BULLETIN NO. 5

East Hampton Town Hall & Police Dept.

Addendum #2

This addendum is issued to show corrections, revisions and clarifications to the Bidding Documents for the Town of East Hampton – Town Hall and Police Department project, dated October 12, 2018.

DIMENSIONING PLAN - 2ND FLOOR

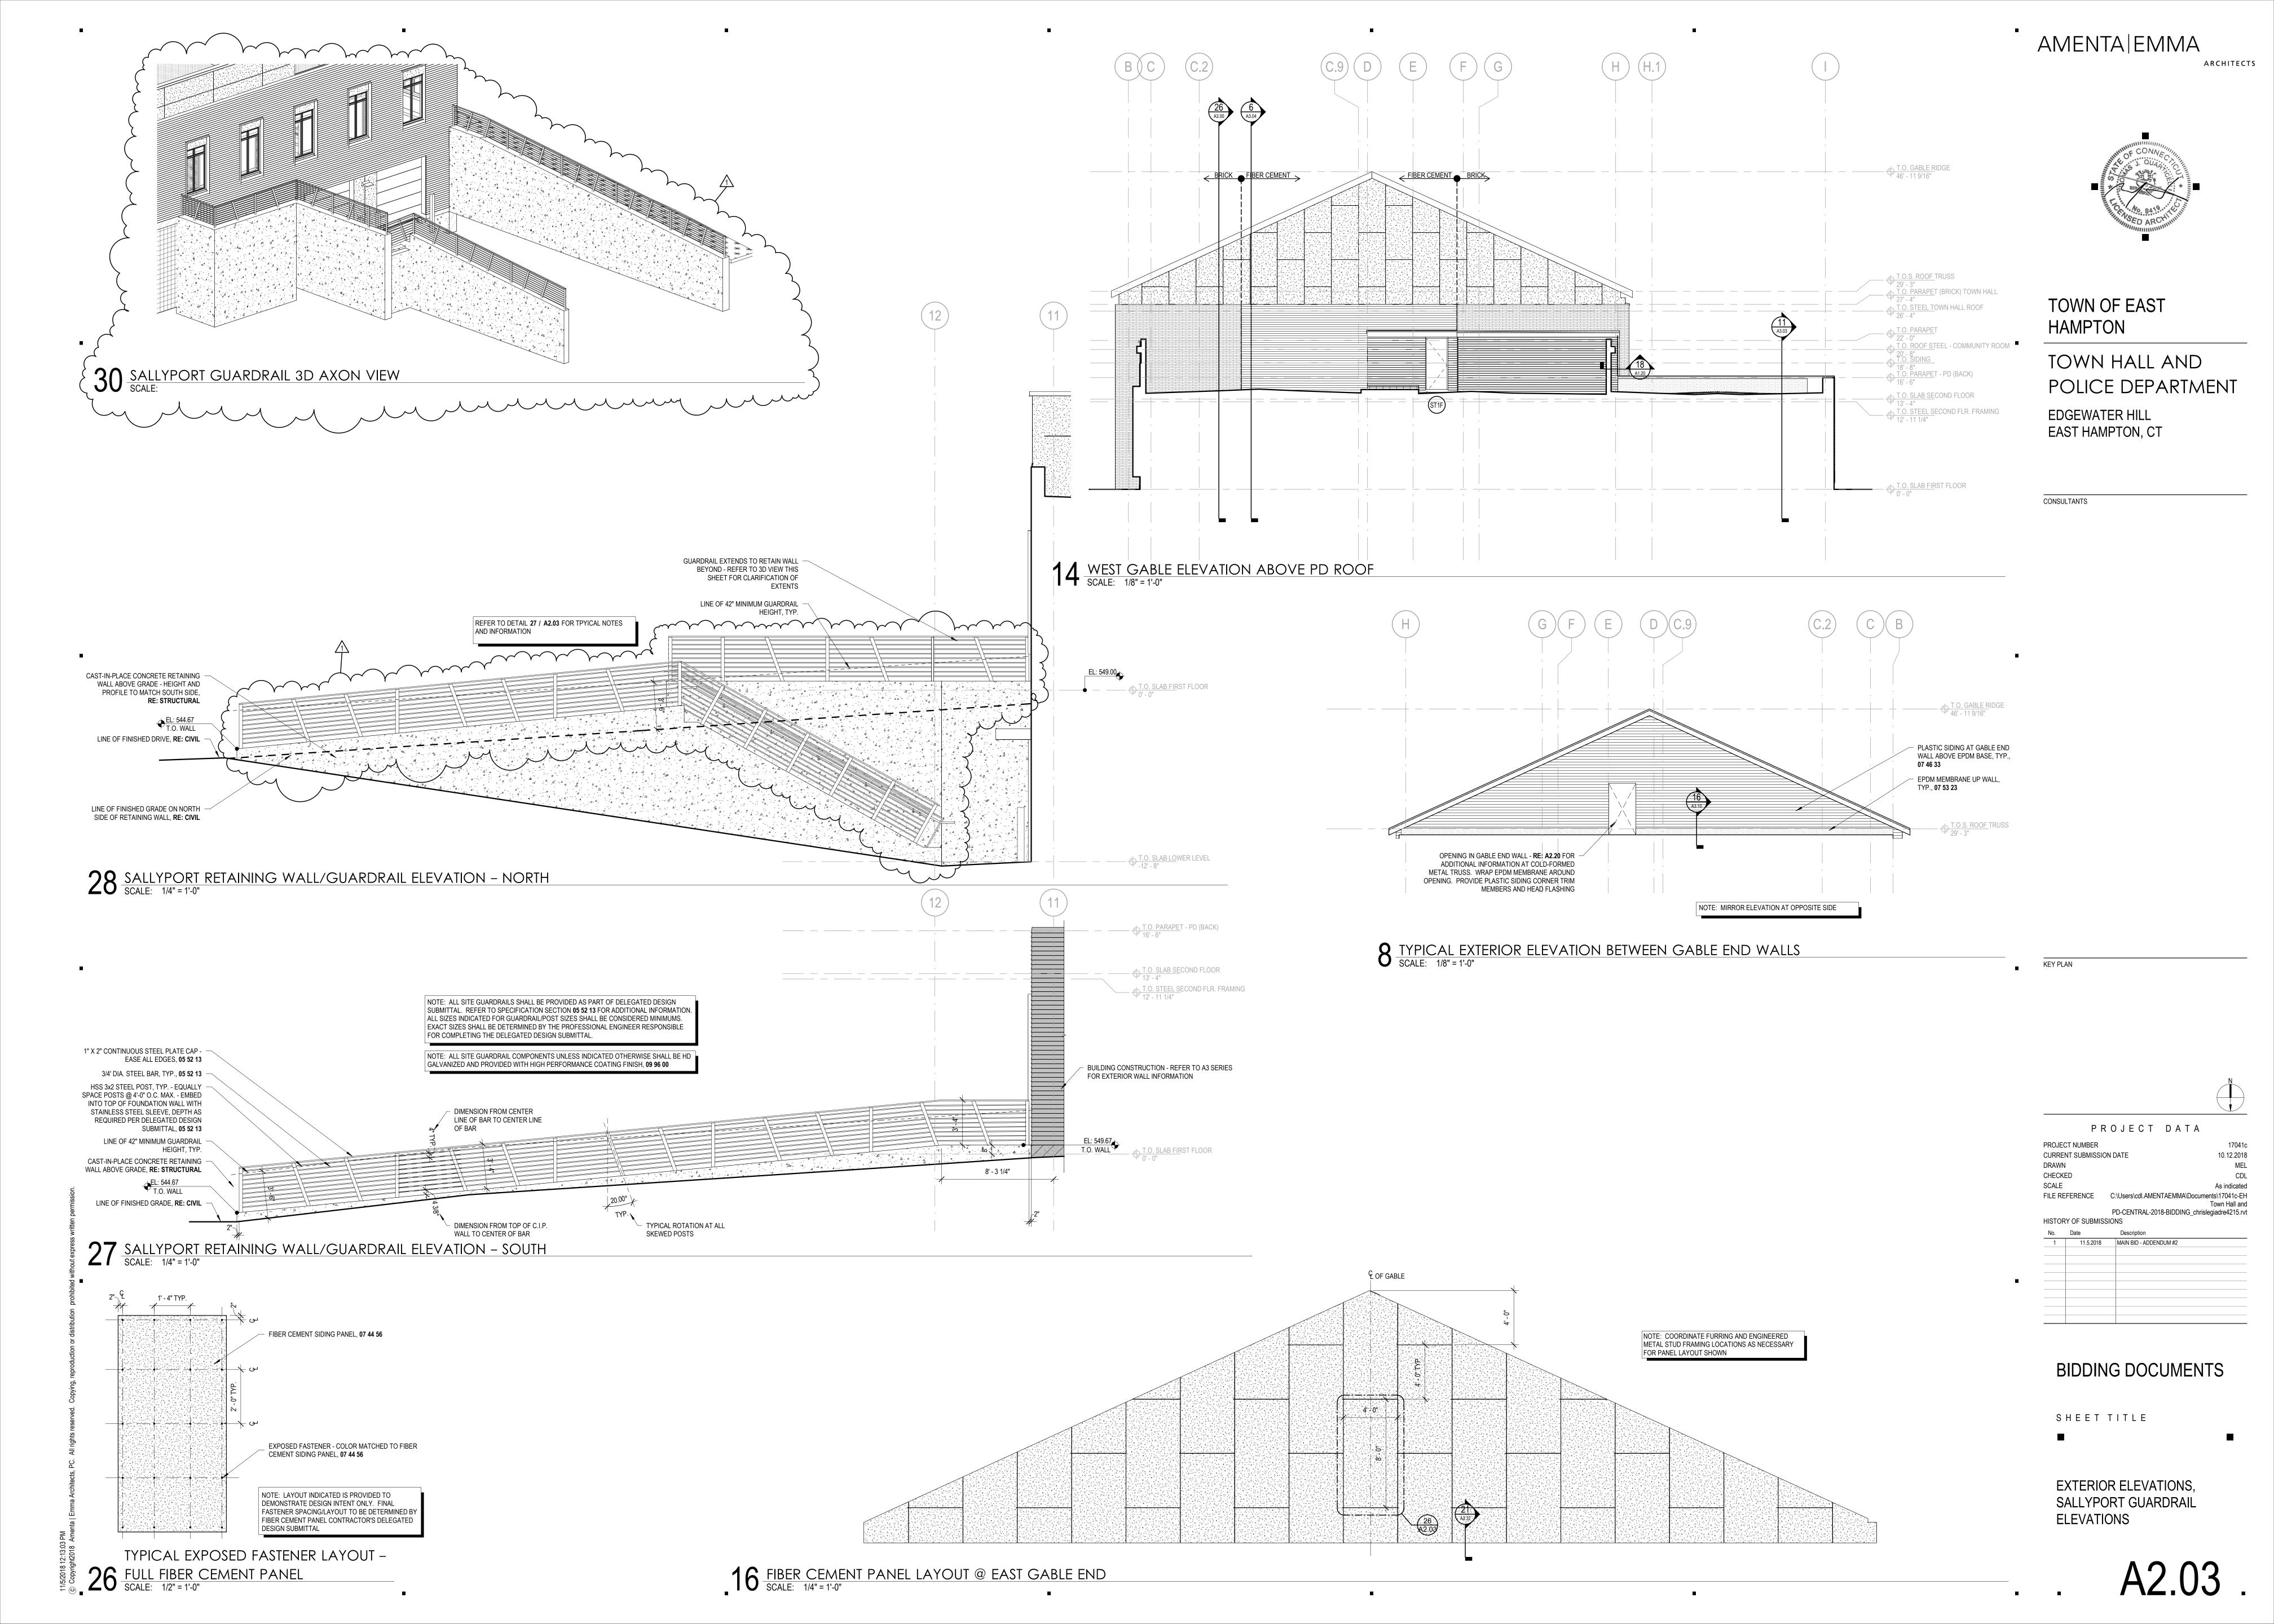
REVISE wall construction between rooms 205B and 205C.

SALLYPORT GUARDRAIL PLANS AND ELEVATIONS

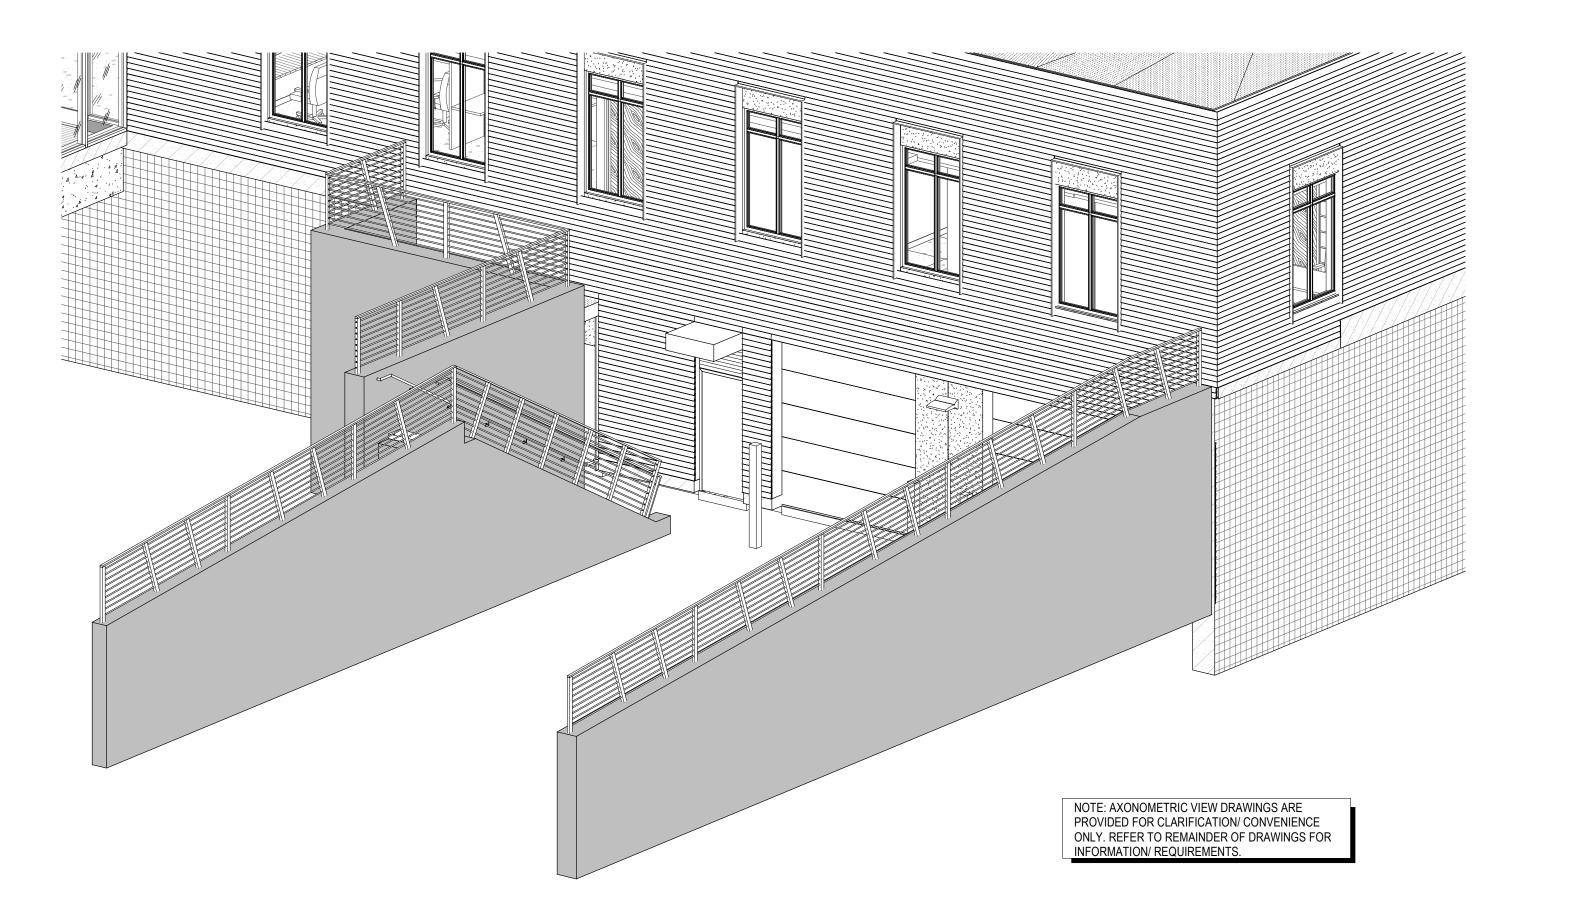
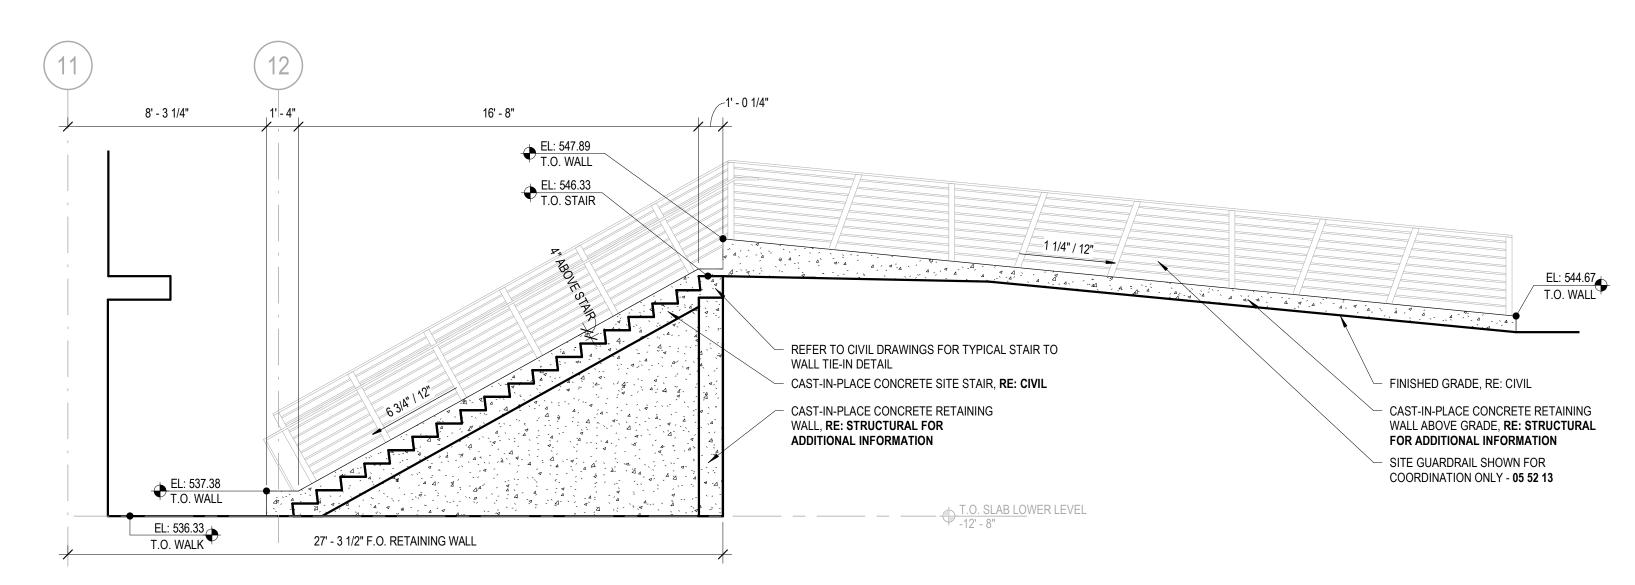
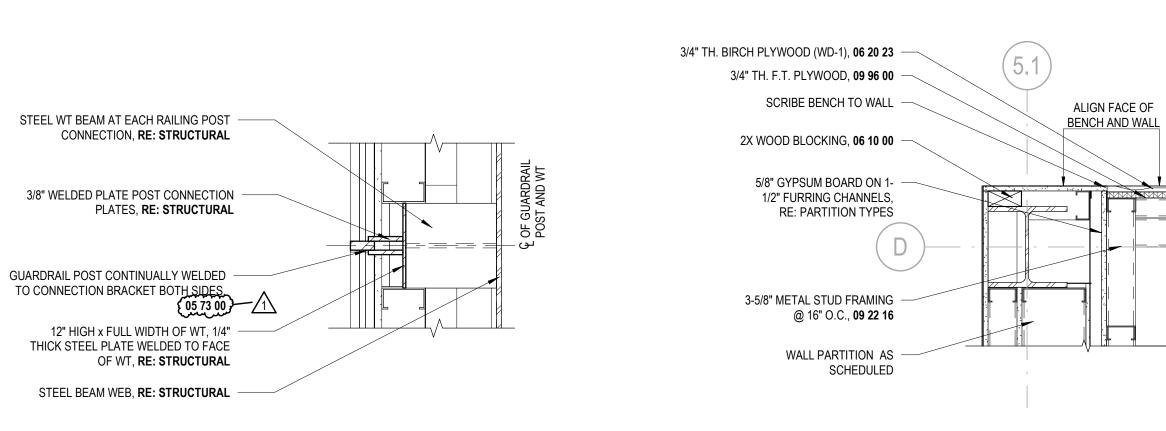
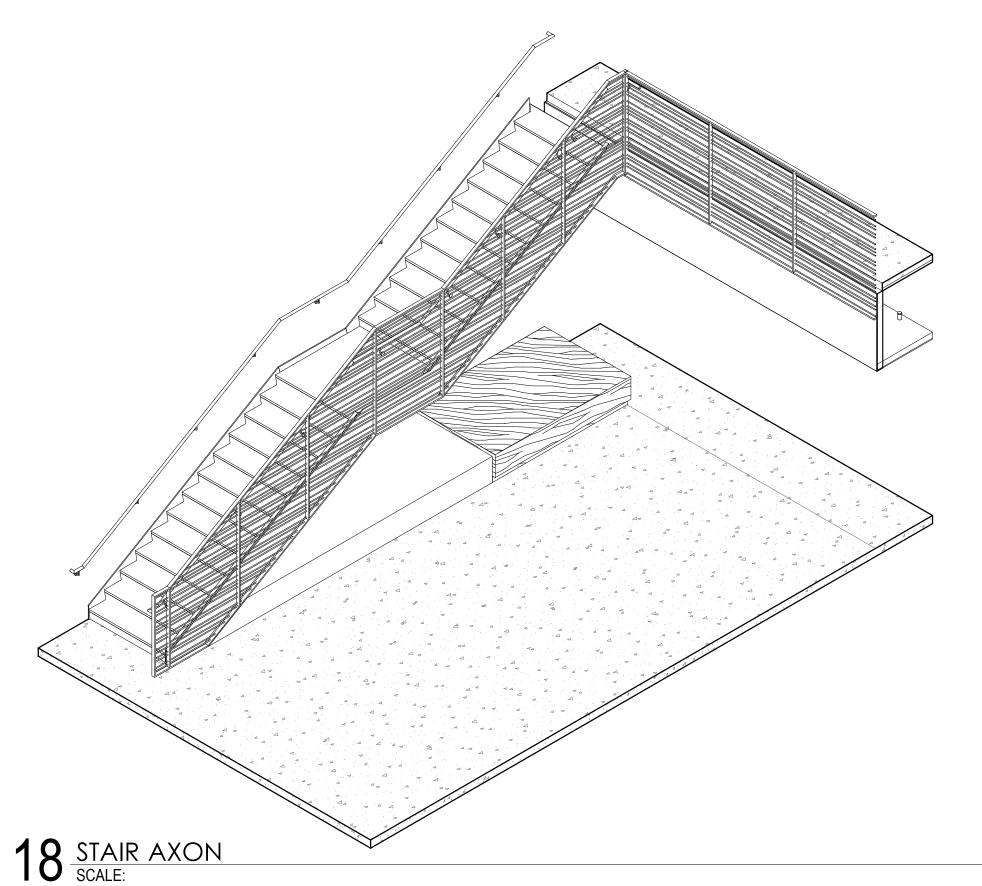
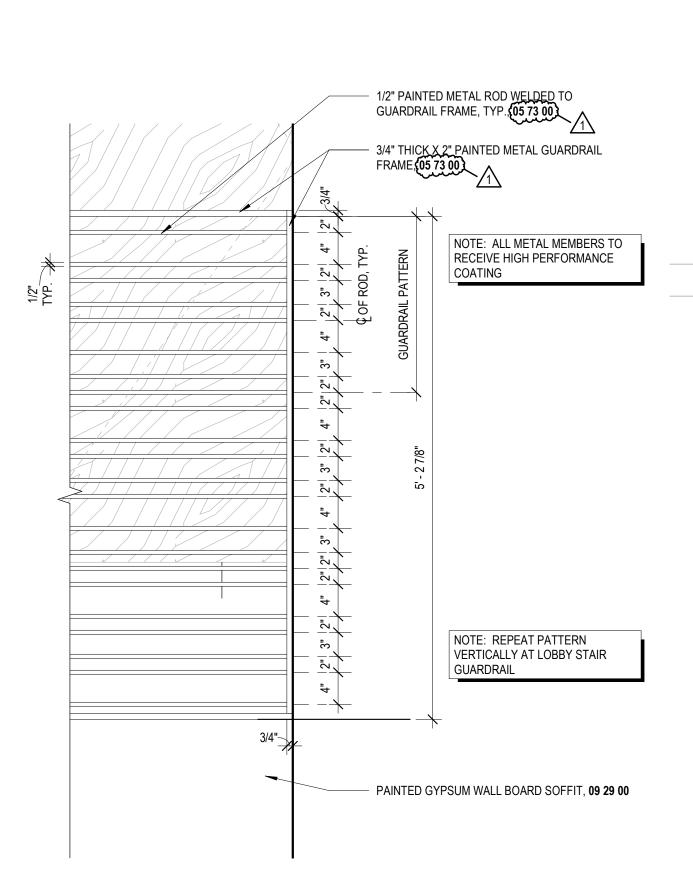
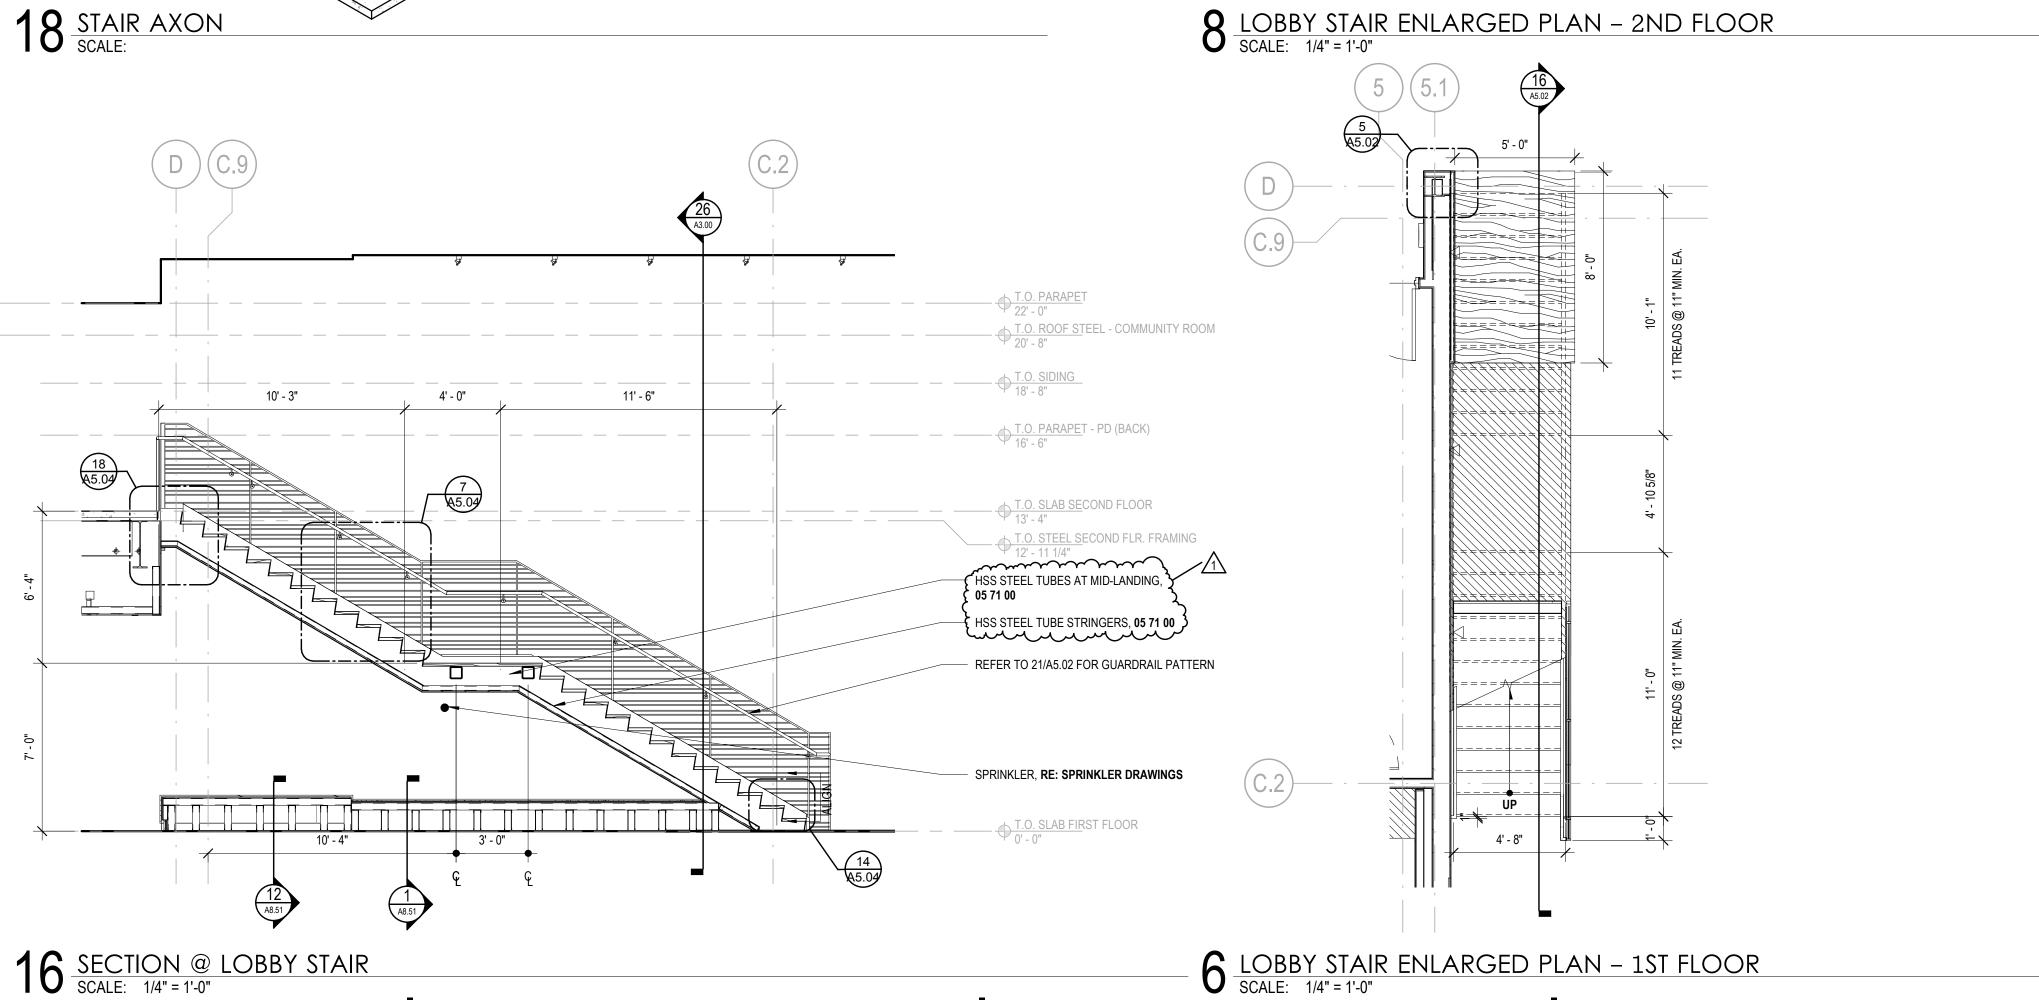
1. **ADD** sheet to clarify guardrail and handrail extents for revised Sallyport retaining wall and stair extents.
